TRANS/WP.29/GRE/2005/37
25 July 2005

PROPOSAL FOR DRAFT AMENDMENTS TO REGULATION No. 112

(Headlamps emitting an asymmetrical passing beam)

Transmitted by the expert from the Working Party "Brussels 1952" (GTB)

"Annex 4 - Appendix 1

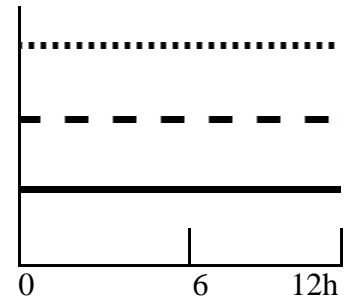
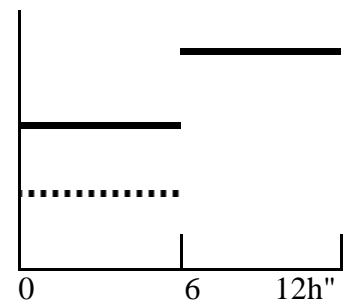
Annex 4 - Appendix 1, amend to read:

P, D or F
Additional light source **or LED module(s)** of bend light

Additional light source **or LED module(s)** of bend light

Additional light source **or LED module(s)** of bend light
